Canberra Pedestrian Forum comments on the Northbourne Avenue bus priority measures and Dickson major bus station feasibility study

Figure 2: Intersection of Northbourne, Macarthur and Wakefield Avenues, showing permitted vehicle flows during the Wakefield Avenue phase.

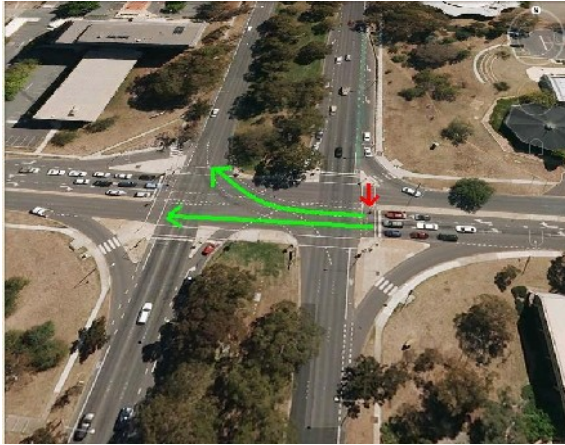
The pedestrian can also safely cross to the median of Wakefield Avenue during the subsequent Wakefield Avenue straight ahead/right turn phase (Figure 2), when approaching traffic on Macarthur Avenue faces red lights. The pedestrian can safely complete his or her crossing during the Macarthur Avenue straight ahead/right turn phase, when approaching Wakefield Avenue traffic faces red lights.

If the pedestrian presses the pedestrian button one second after the commencement of the Northbourne Avenue green phase, the pedestrian light remains red for the remaining 54 seconds of the green phase, for the entire Wakefield Avenue phase and for the entire Macarthur Avenue phase – even though during these phases the potentially conflicting traffic streams face red lights.

This delay contributes to a high rate of pedestrians choosing to cross either mid-block (31%) or against red pedestrian signals (42%). These crossings are eight times as dangerous as crossing with a green pedestrian signal^{6,7}.

Safety - program pedestrian signals to show green when it is safe to proceed
